Historical Architectural Review Board COA Preliminary Review Sheet

HDC-2025-00086

Address: 126-128 N 15th Street

Proposal: Roof Replacement (Violation Correction)

Proposed Material (Applicant)

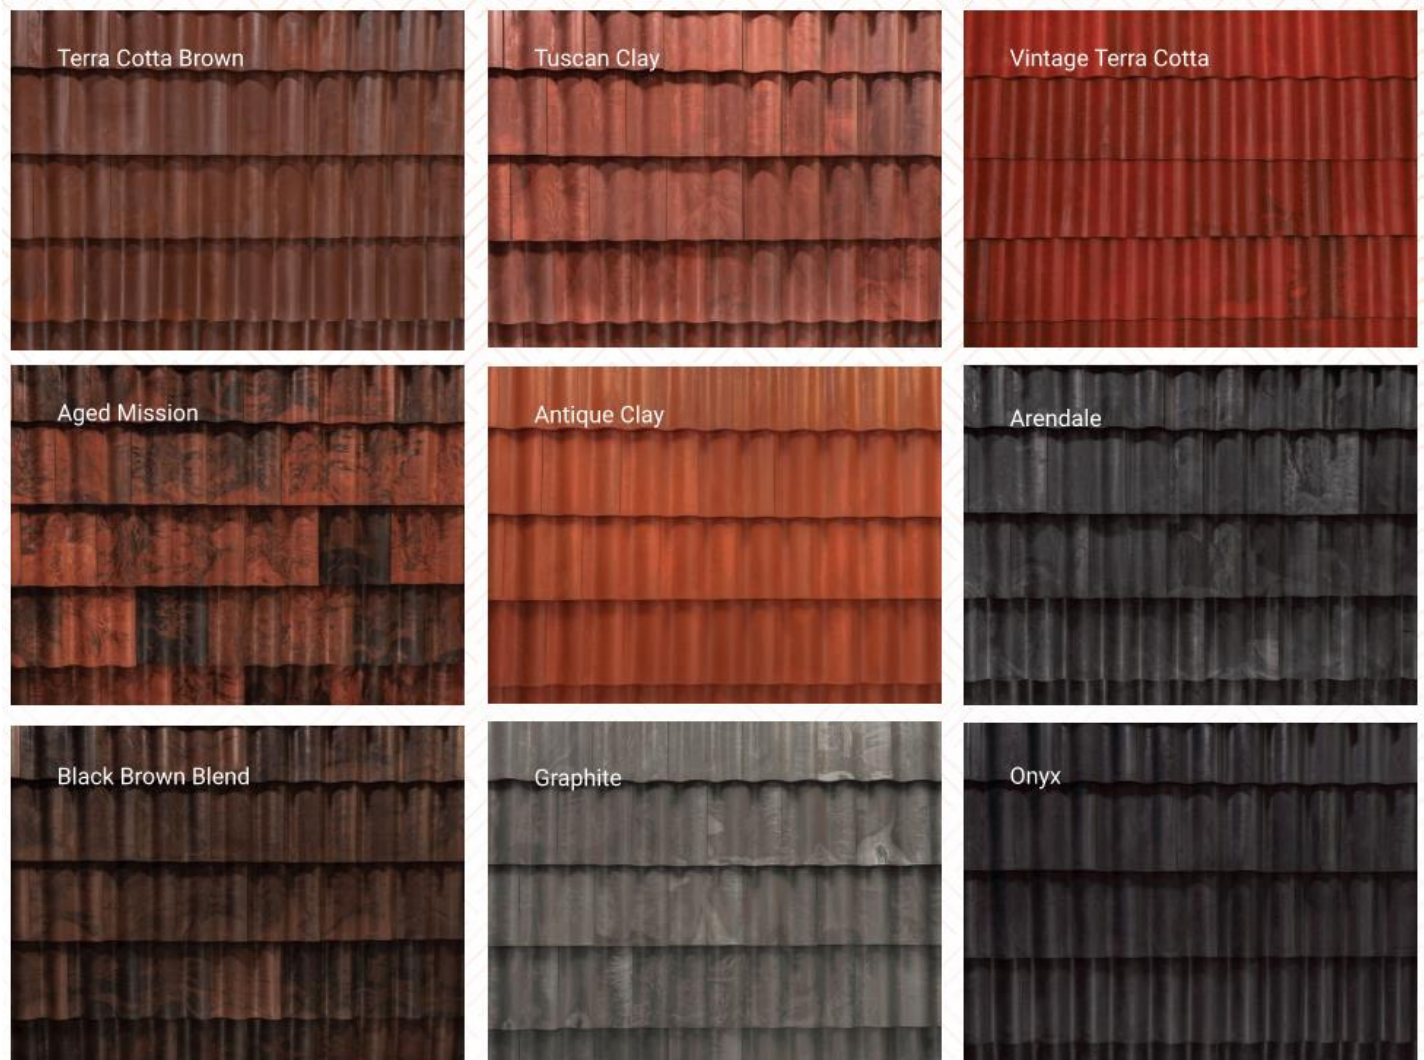
Observations & Comments: The original roof of 126-128 N 15 Street was Spanish barrel terra cotta clay tile. It appears that the original roofing materials have been completely removed at the main roof areas, and replacement with a red shake style architectural asphalt shingle was begun until work was stopped. The applicant has submitted an alternate material for review: Brava's Spanish Barrel Tile, a synthetic material that matches the original clay tile. This product appears to be an appropriate alternate material, as color options, profile, and appearance are consistent with the original historic clay. No specific color was proposed by the applicant. From the color chart, Antique Clay appears to be the closest match to the original clay; the applicant may obtain samples and submit photos to Staff showing the sample and the remaining original tile for final color selection.

The applicant provided physical samples of Brava product; she noted that the samples show the Slate line, and not the Spanish barrel tile that is proposed for the project. The HARB reviewed the samples and product information and generally agreed that the Brava synthetic Spanish barrel tile appears to be an appropriate alternate material. The applicant noted that the bands of clay tile above the first floor level and at the gable ends are to remain, as are the existing gutters and downspouts.

The Board discussed roof detail areas, including hips, rakes, and ridges. Mr. Knee noted that these elements should be consistent across the roof. Mr. Hart noted that those elements are included in the manufacturer's product information. The applicant stated that all elements for the roof will be from the same manufacturer. Mr. Huber noted that the original valleys appeared to be open and copper. The applicant was unsure how the roofer would be detailing the valleys. The Board discussed that multiple approaches can be included in conditions. Mr. Knee noted that the valleys could be open or closed. Mr. Huber expressed that if the valleys were open, they should be copper to stay in keeping with the original material.

- Samples of the barrel configuration with colors closest to the existing color is submitted to staff for color approval. Photos submitted should show the samples next to the existing/original clay roof tile.
- The hips, rakes, and ridges are consistent in design throughout the roof and submitted to staff for approval.
- Detail for valleys to be submitted to staff for approval; if valleys are open they are to be copper, or the valleys can be closed as suggested in the manufacturer's documentations.
- The existing gutters and downspouts are maintained.
- If there are any other changes to roof components, a separate application will be made.
